# Roadway Plans\_V1.pdf Markup Summary

# CONSTRUCTION PLANS

CLEARWAY FILING NO. 2, LOT 5		TITLE SHEET	
PROJECT NO. 44-042A		DATE: 06-02-2022	
DESIGNED BY: DIM		SCALE: HORIZONTAL: N/A	
DRAWN BY: CLP		VERTICAL: N/A	
CHECKED BY: DIM		SHEET 1 OF 15	
TS01

**MAINT AND ACCESS ROADWAY PLAN**  
SCALE: 1" = 5'

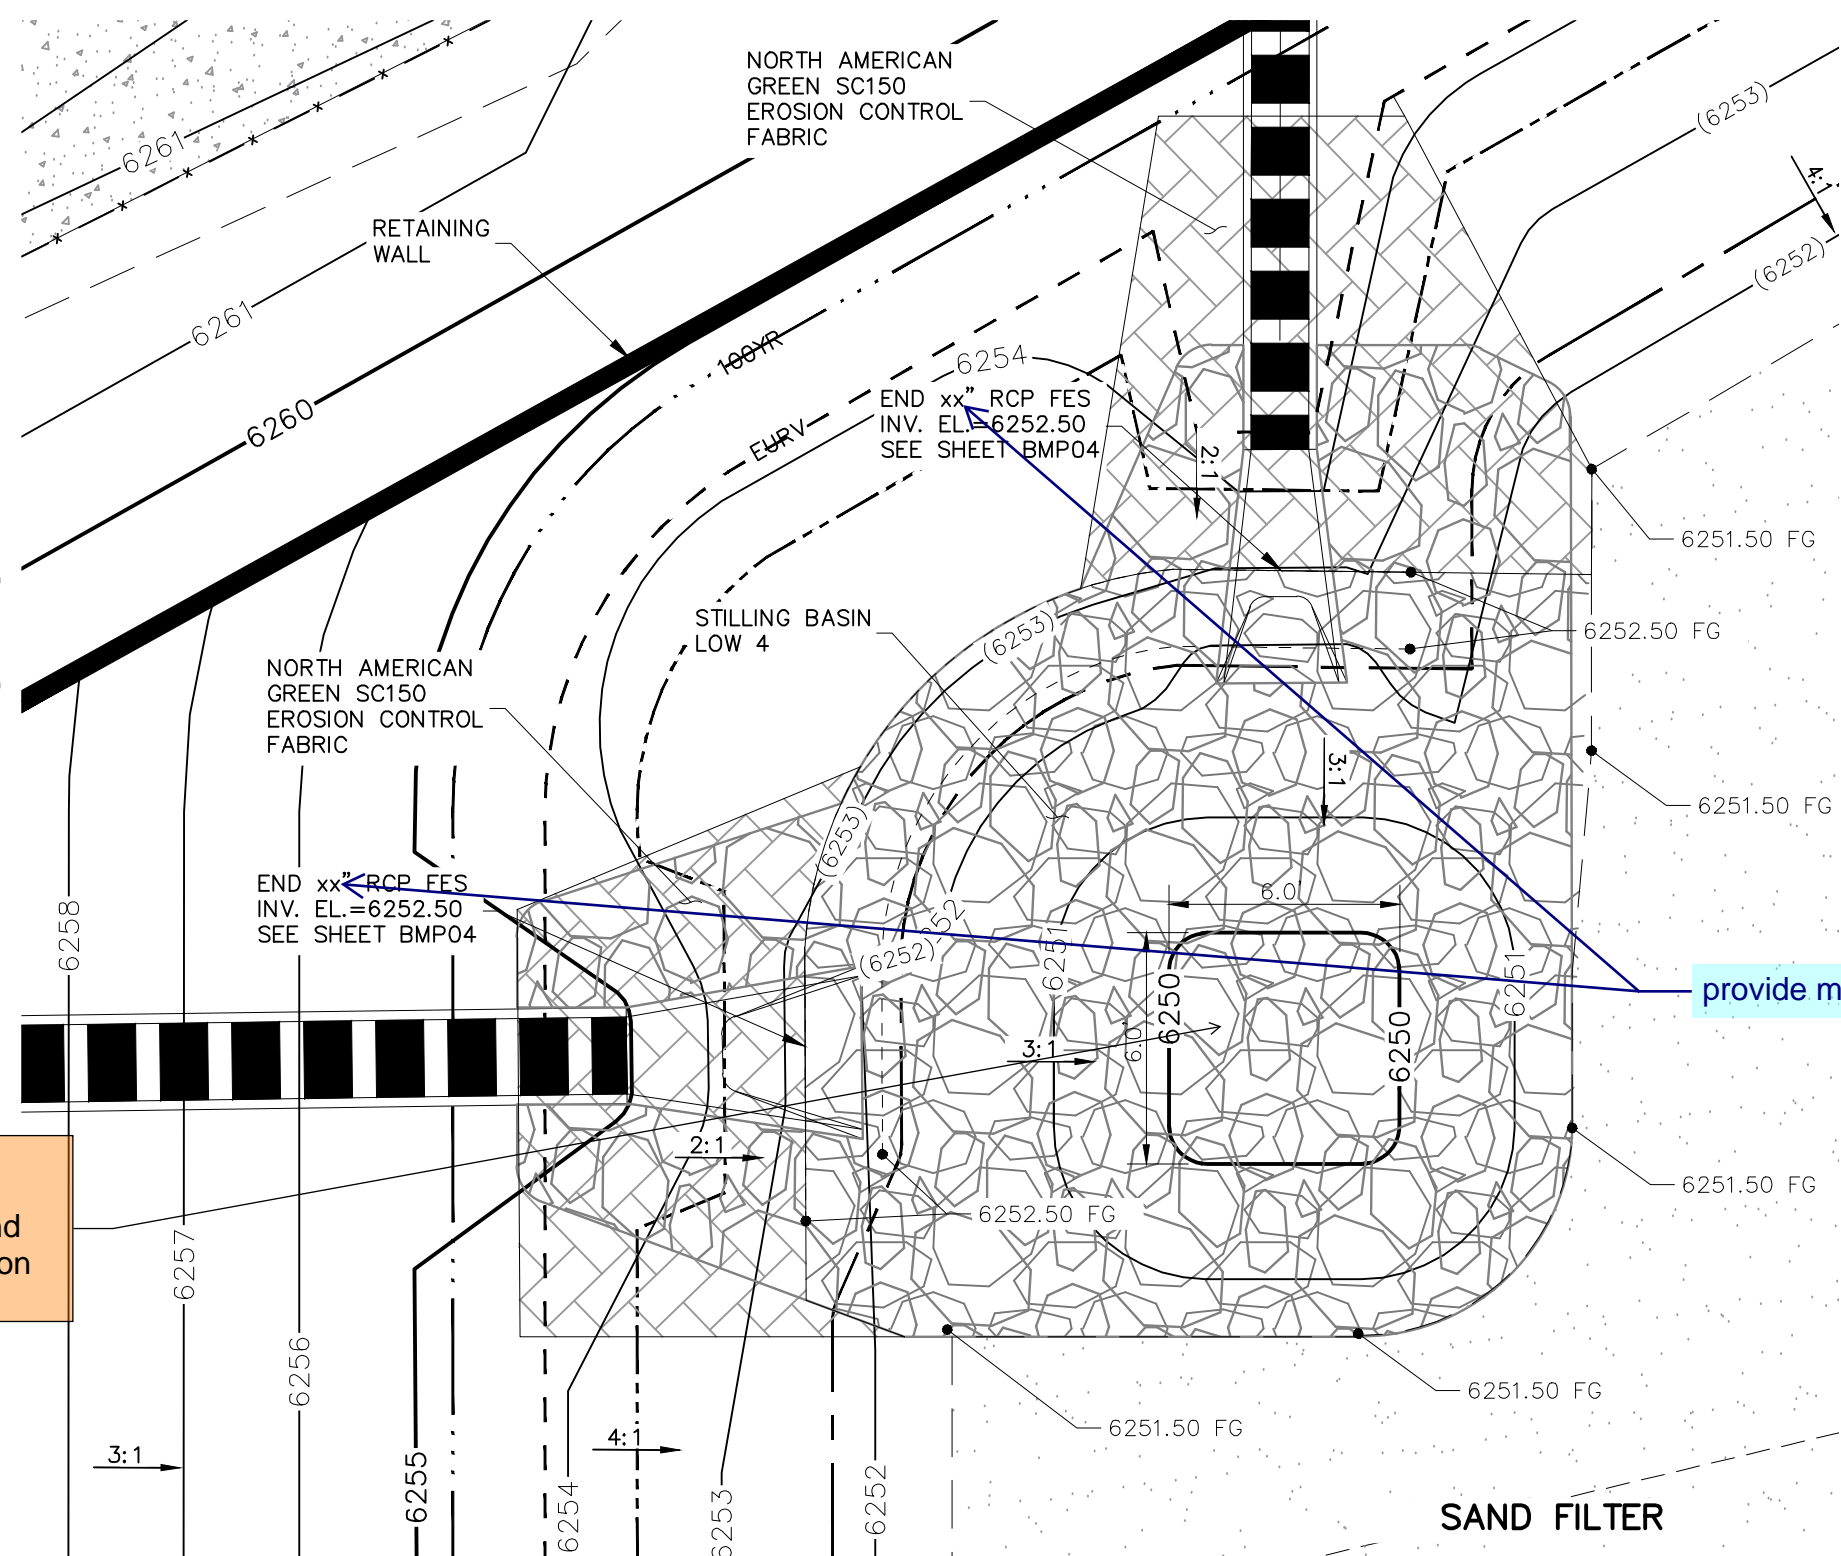
provide sizing calculations in drainage report and show dimensions on plans

revise detail title
